DESIGN ADVISORY BOARD Tuesday, December 9, 2014 Conference Room 12, City Hall, Burlington, VT AGENDA

MEMORANDUM

To: The Design Advisory Board
From: Mary O'Neil, AICP, Senior Planner
RE: ZP15-0656CA/MA; 289 College Street
Date: December 9, 2014

Request: Addition of 12 residential units to existing mixed use building (office and 1 residential unit) for a total of 13 residential units and office use.

DRAWING NUMBER: C1.1

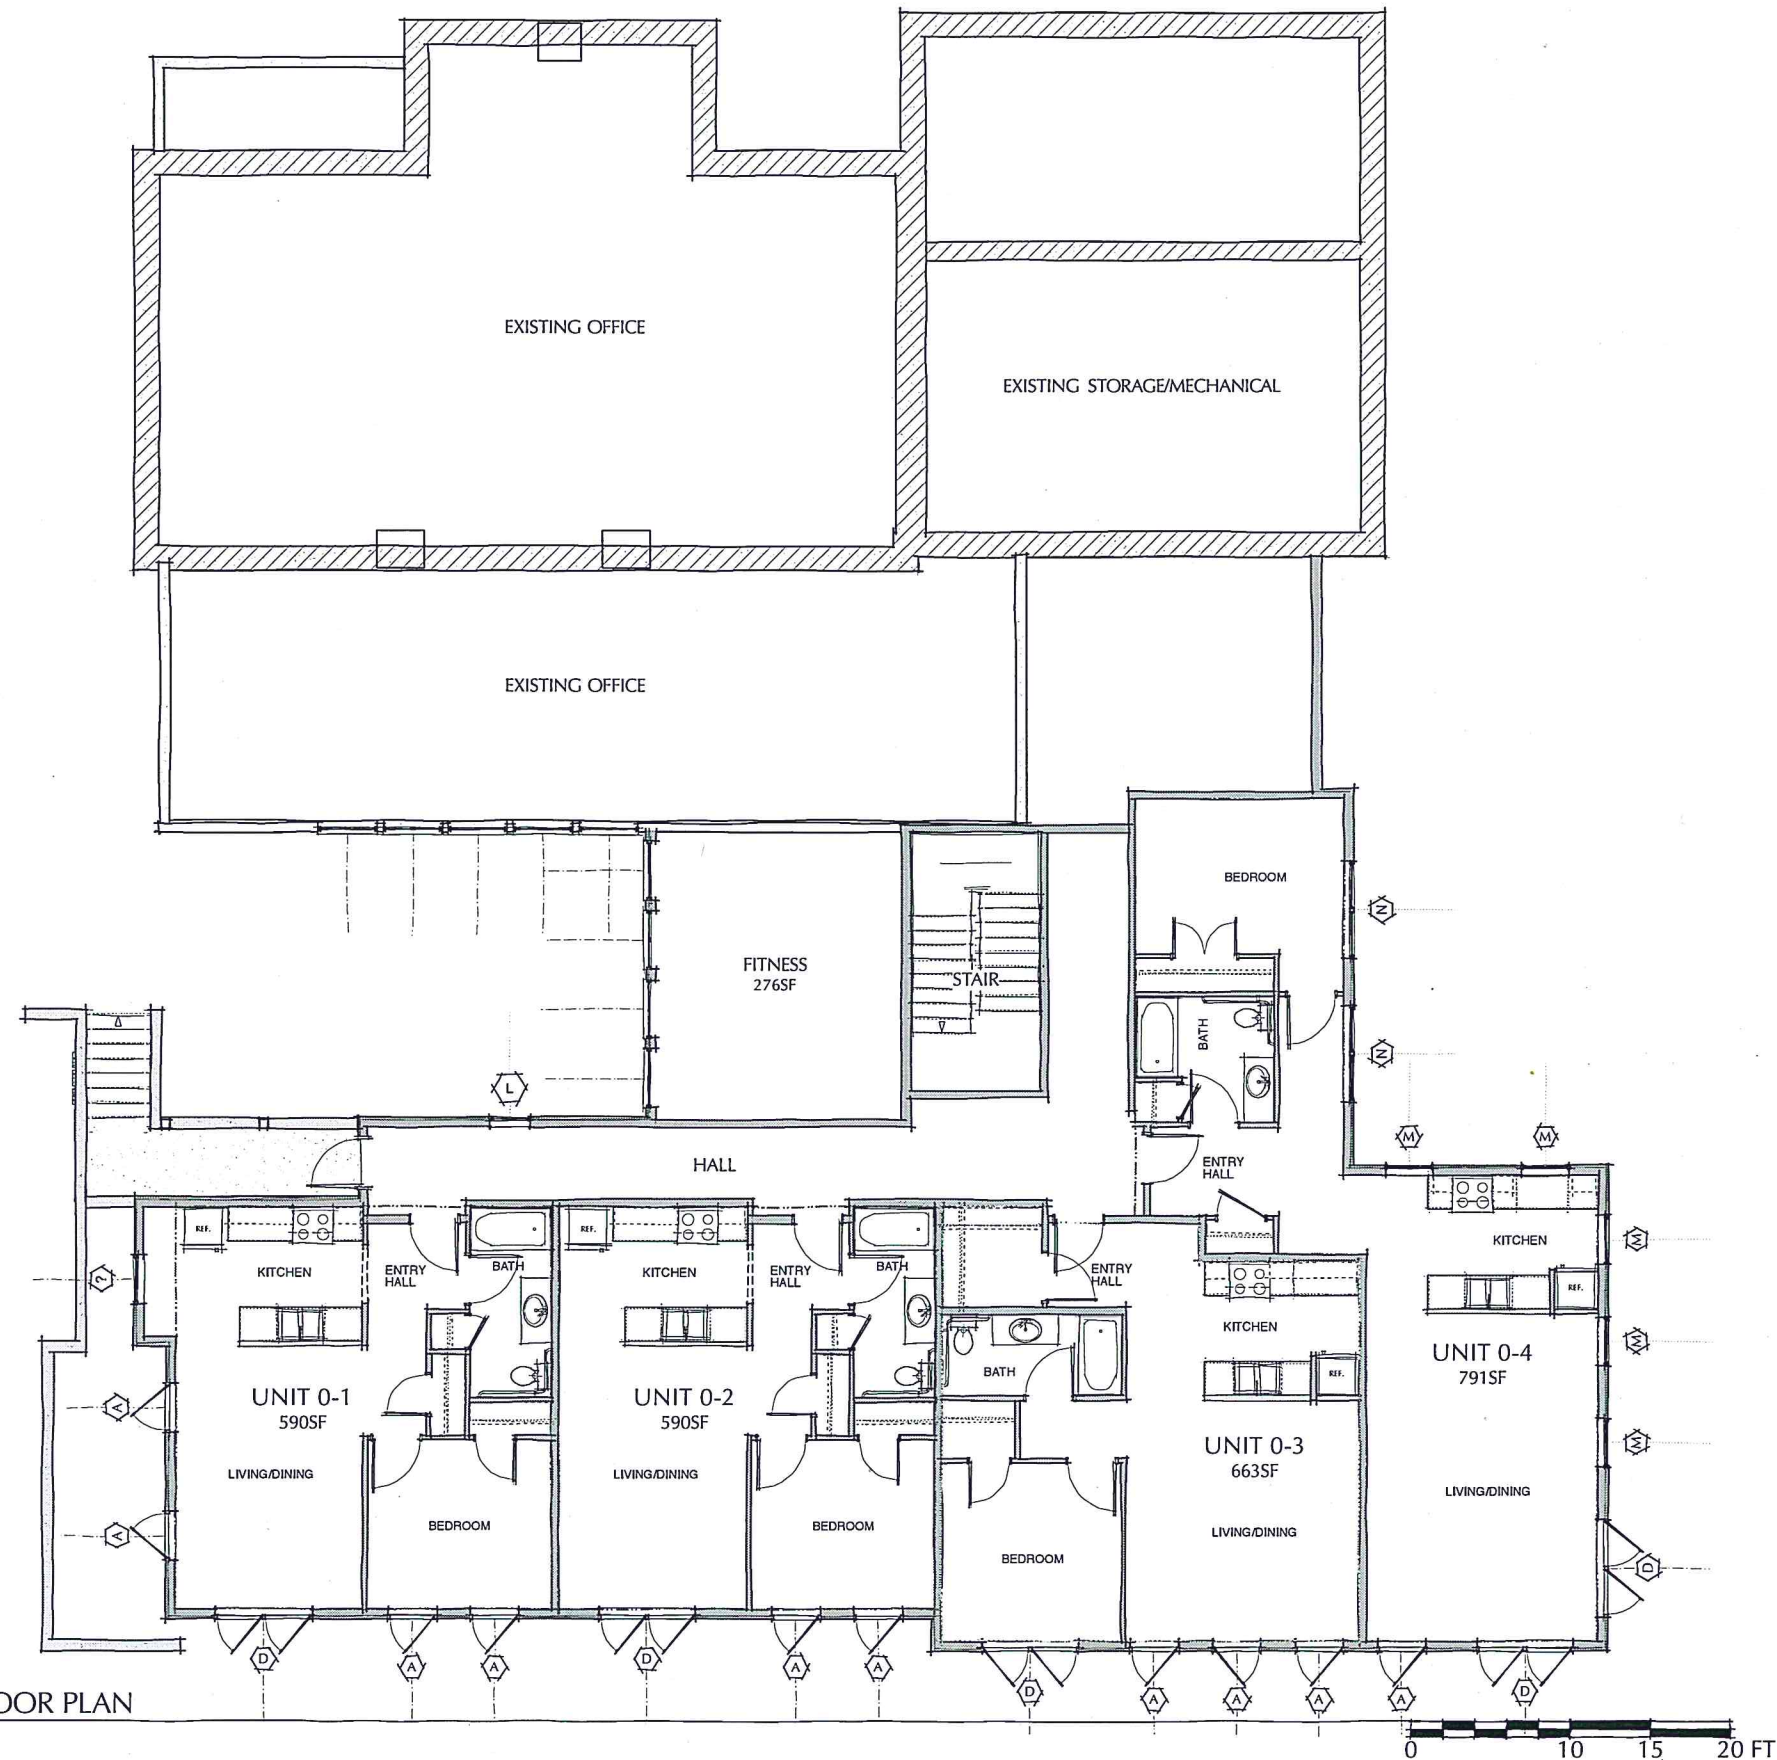
As illustrated in plan C1.1, the building frontage line does not match with provided elevations in that the protruding bay is in reverse on the façade. Plans need to be consistent.

A small concrete entrance ramp is identified on the site plan for the rear entry; however there is little separation between vehicular parking and the rear building entrance. An identified pedestrian path between the parking area and the rear entry is required.

A dumpster is identified on the east of the site, abutting a property line. Although annotated as “existing”, this component is not on any previously approved site plan, and has been placed within a required setback. The dumpster and its enclosure will need to be relocated on the site, meeting setbacks and enclosure requirements as specified in this standard.

2. Lighting fixture locations, height, and a photometric plan shall be required for staff review for compliance with Section 5.5.4.
3. A pedestrian walkway between the parking lot and the building entrance shall be identified on the plan.

PROPOSED LANDSCAPING PLAN

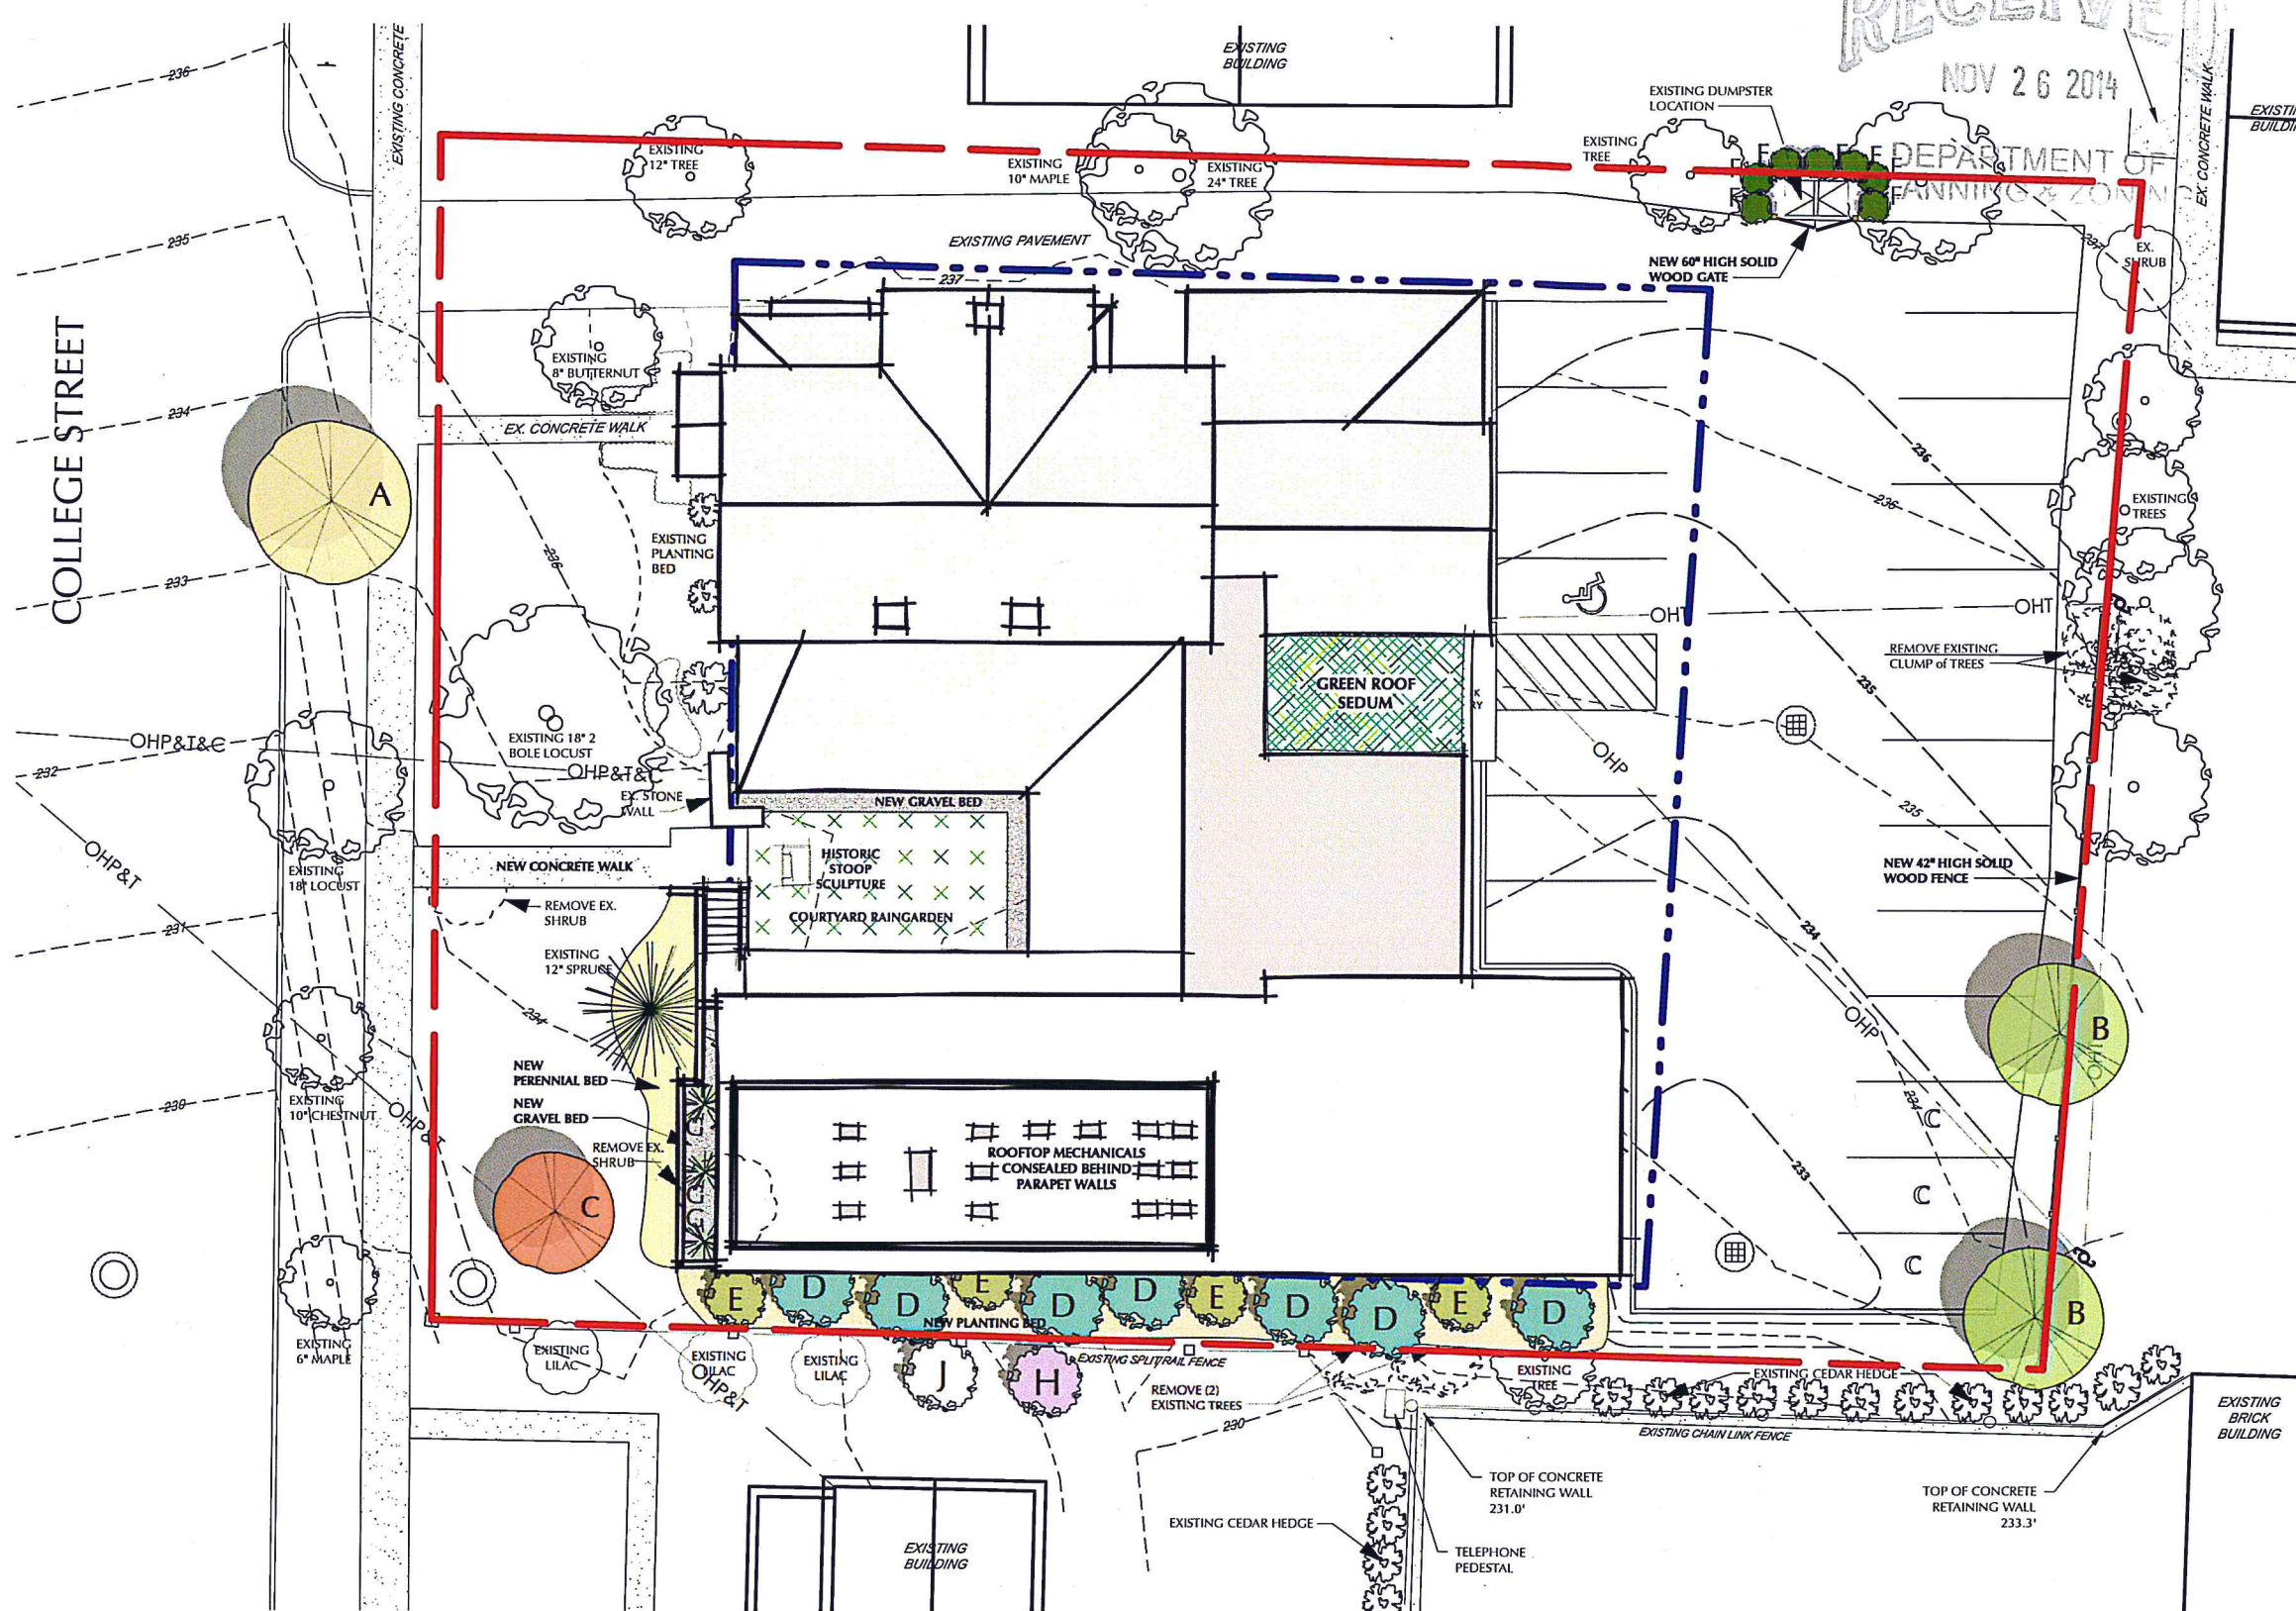
The landscaping plan provides for 2 new shade trees (Honey Locust) at the south of the parking lot. For 20 parking spaces, 4 trees would be required to meet this standard. There are existing trees to the south of the lot, but remain on the abutting property. Similarly, 2 trees are illustrated to the east; however not entirely on this parcel. The DRB will be required to

A landscaping plan has been provided (Plan L1-1.0.) The street tree species and number shall be selected in coordination with the city arborist.

NORTH ELEVATION
Scale: 1/16" = 1'-0"

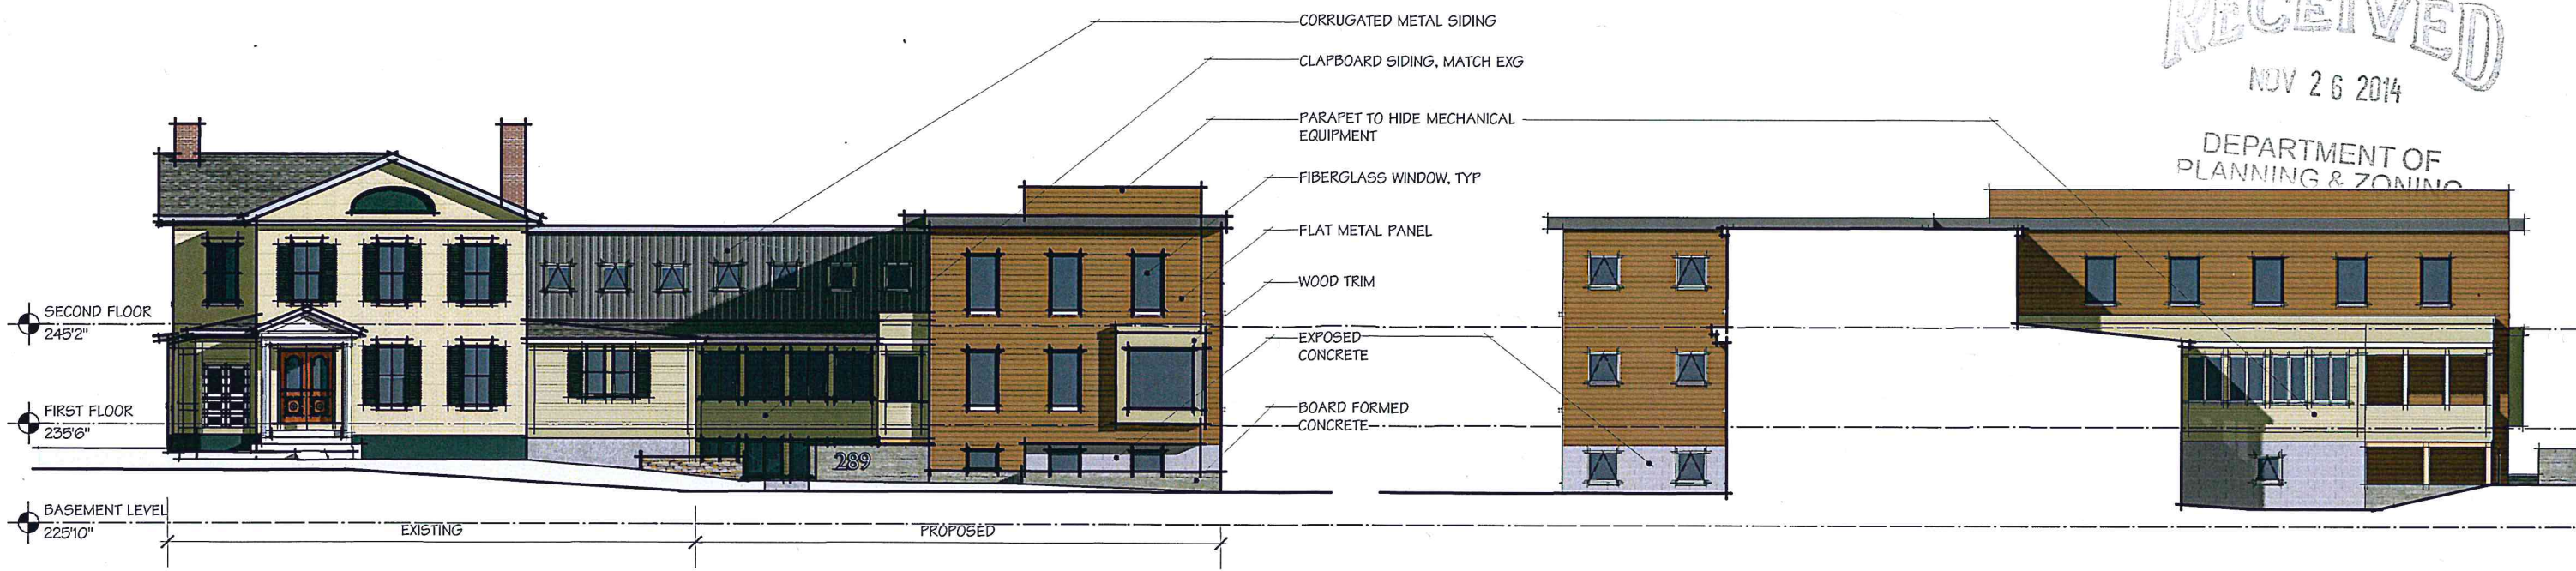
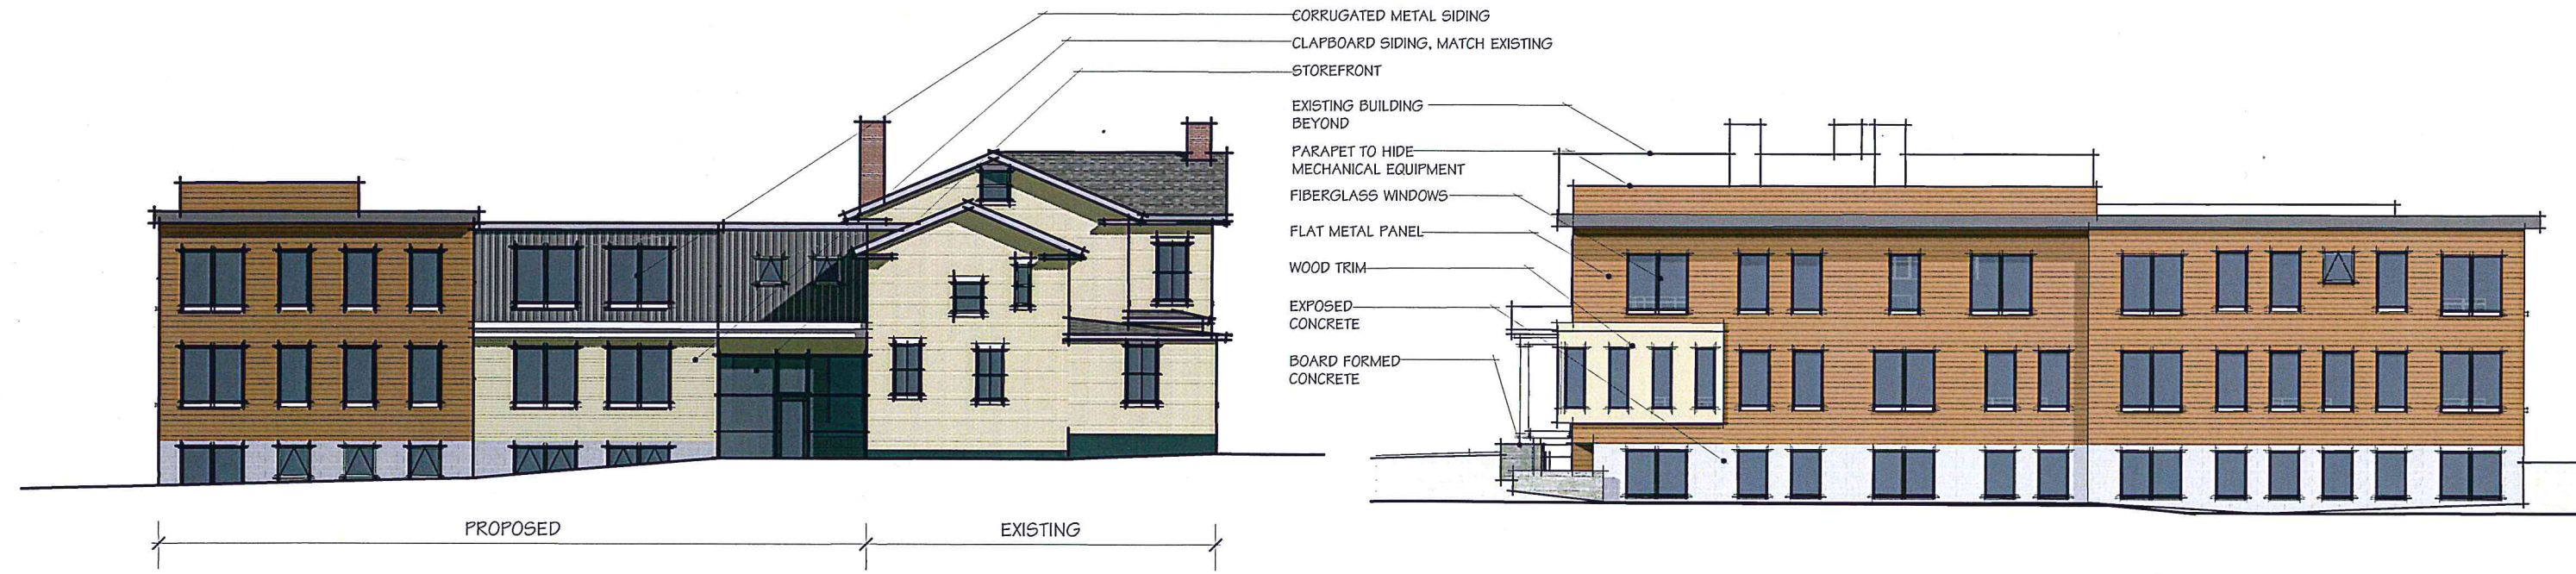
The submitted narrative suggests that window placement attempts to reflect the rhythm of the existing historic building. Certainly from the west, they appear more horizontal than vertical. The windows themselves are without detail; casement and/or slider operation (or fixed light, in the case of the window bay.) The arrangement is inconsistent from floor to floor and room to room (singles, pairs) although the smaller awning on the upper floor west identifies a bathroom. There is no identified rhythm to the overall placement along the westerly façade.

The blunt cubist theme has a strong horizontal cornice line, continuous around the perimeter of the building and echoed in the horizontal metal siding. A small 1st floor bay projection hugs the northwest corner, and is punctured with a fixed window on the north and four casements on the west. The ground floor is mostly obscured from (College) street view by the change of grade and a constructed window well, although a vantage from the west provides more visibility.
